APL 17-001

APPEAL OF DECISION OF PLANNING AND ECONOMIC DEVELOPMENT COMMISSION

# Town of Mammoth Lakes Planning & Economic Development Commission Staff Report

<b>Date:</b>	June 14, 2017	<b>File No.:</b>	Design Review (DR) 16-012; Lot Line Adjustment (LLA) 16-002
<b>Place:</b>	Council Chambers, 2 <sup>nd</sup> Floor Minaret Village Shopping Center Mammoth Lakes, CA 93546	<b>Project:</b>	Grocery Outlet
<b>Time:</b>	After 2:00 p.m.	<b>General Plan:</b>	Commercial 2 (C-2)
<b>Appeal Status:</b>	Appealable to the Town Council	<b>Specific Plan:</b>	N/A
<b>Applicant / Owner:</b>	Best Development Group / Vereuck Rev. Trust	<b>Zoning:</b>	Downtown (D)
<b>Environmental Review:</b>	Categorical Exemption (CEQA Guidelines Section 15332 – In-Fill Development Projects)	<b>Location:</b>	37 and 77 Old Mammoth Road

EXTERIOR ELEVATIONS

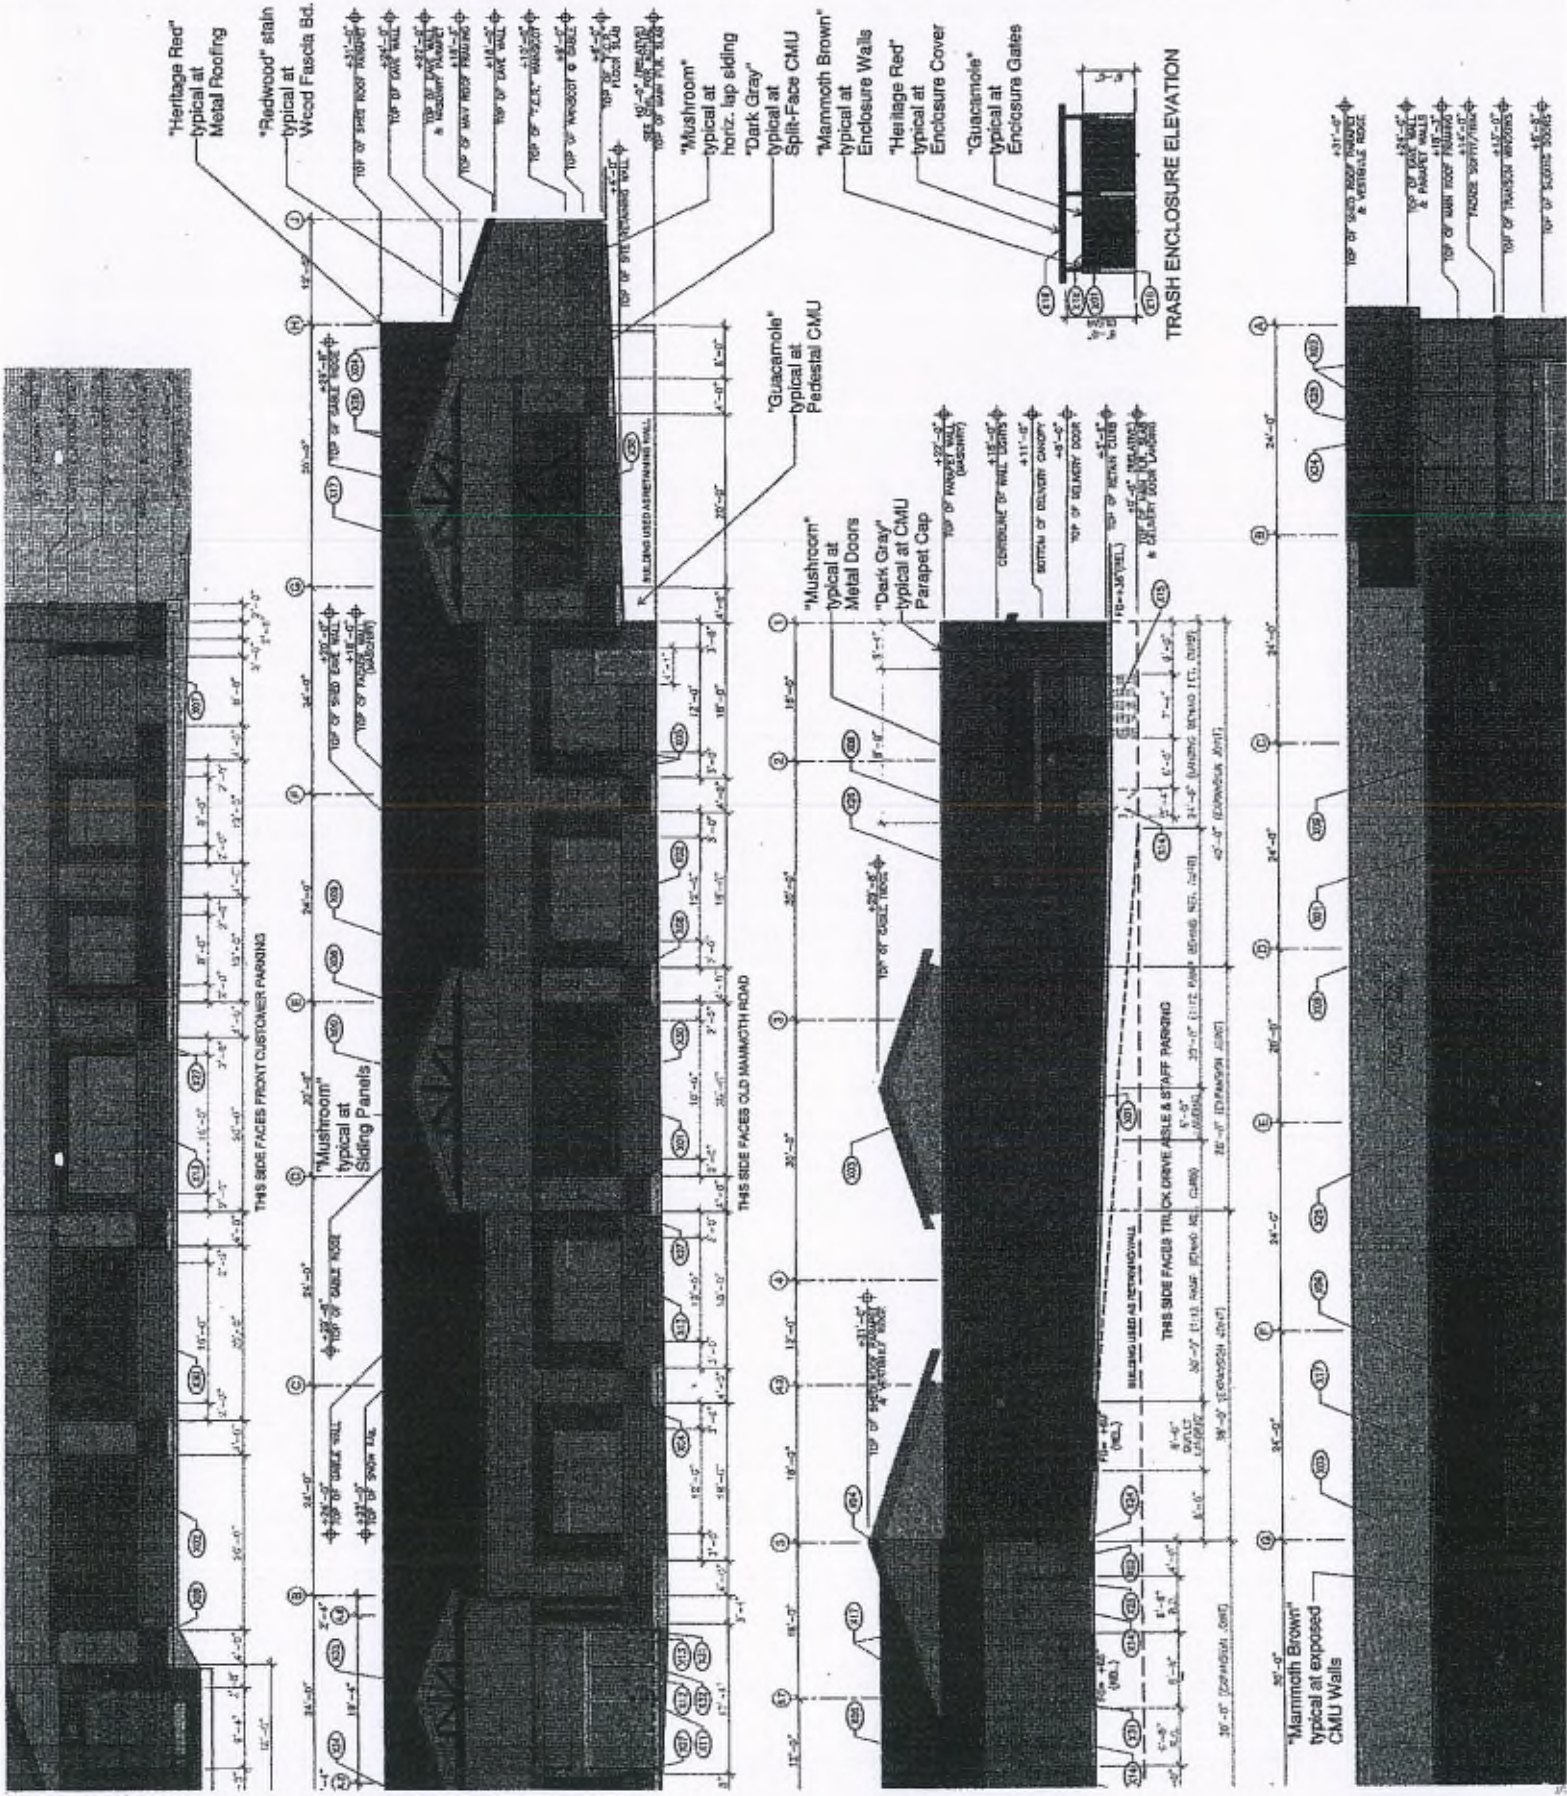
Comment	Response / Revised
The pitched roof on the parapet is a desirable architectural feature, however, there are concerns that snow will shed into the pedestrian areas.	The applicant indicated that the pitched roof is at a relatively low angle (4:12) and there are landscaped areas below that will provide a buffer between the building and the sidewalk. Additionally, snow rails will be installed along the roof edge and a snow fence will be installed adjacent to the bus stop area to further protect the pedestrian area.
The proposed colors are generally consistent with the color handbook, but slightly darker shades would be desirable.	The original submittal proposed tan and ivory as the primary building colors. Based on the Design Committee and staff's comments, the applicant revised the building colors and proposed colors that were darker and more appropriate for the area. The revised colors are consistent with the Color Handbook and the Design Guidelines. See Attachment 2 – Materials Board for the proposed colors and Sheet A6 for the colored elevations.

The southwest corner of the building needs additional articulation so that it complements the rest of the building ( <i>The original building elevations reviewed by the Design Committee had a flat roof with no gable on the southwest corner</i> ).	The applicant revised the southwest corner of the building and added an additional gable roof section so that it matched the other portions of the building. The Design Committee reviewed this modification at the May 11 <sup>th</sup> meeting.

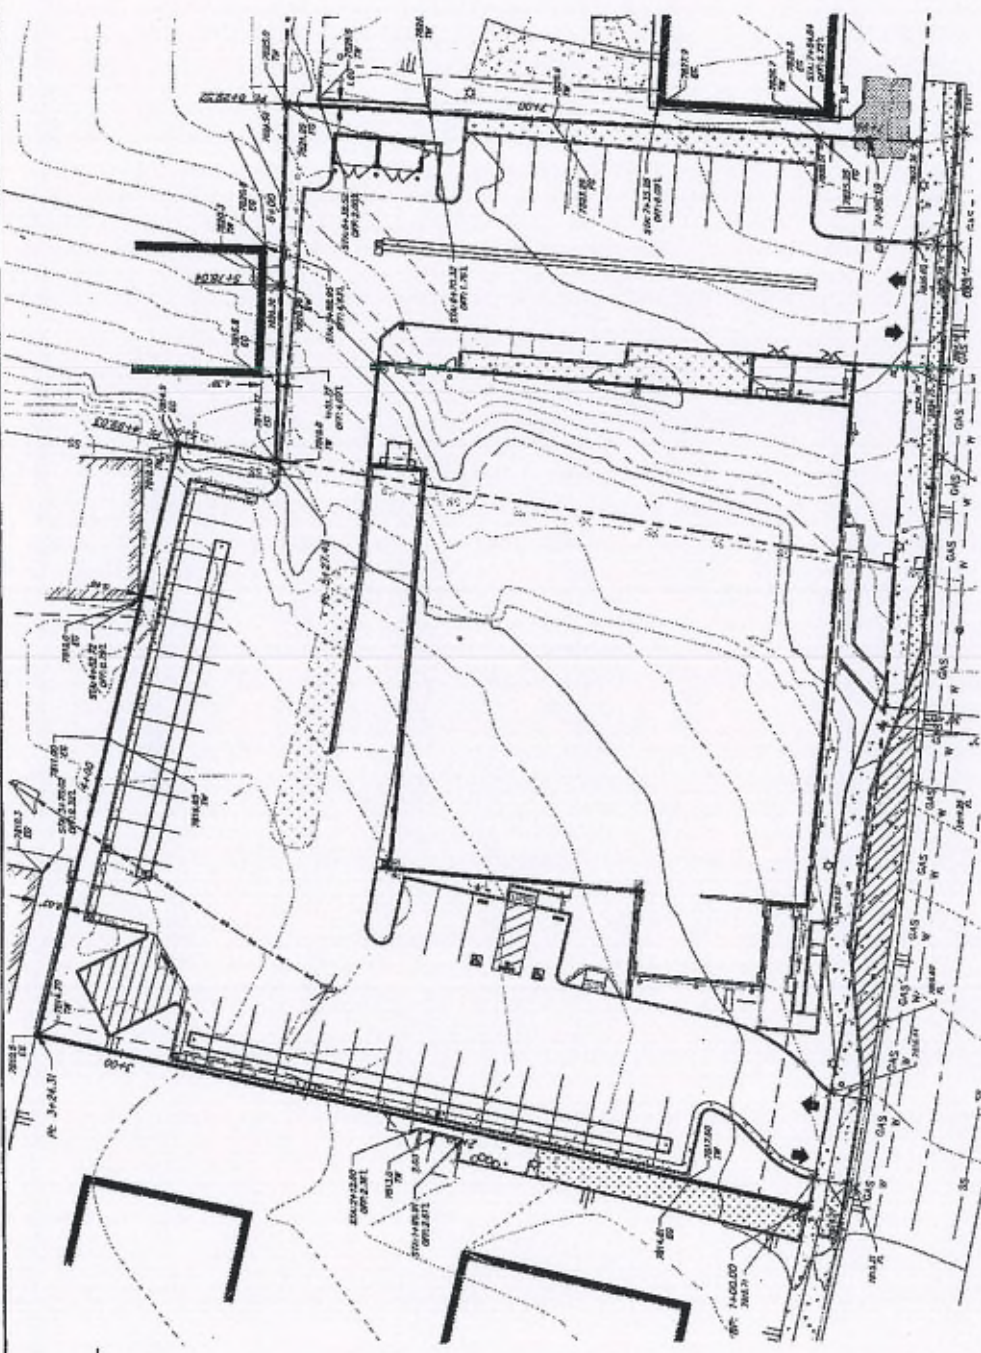
17. Sheet C2 indicates that the propane gas line runs under the slab of the structure the full length of the building to reach the meter on the south side of the structure. This may need to be reevaluated.
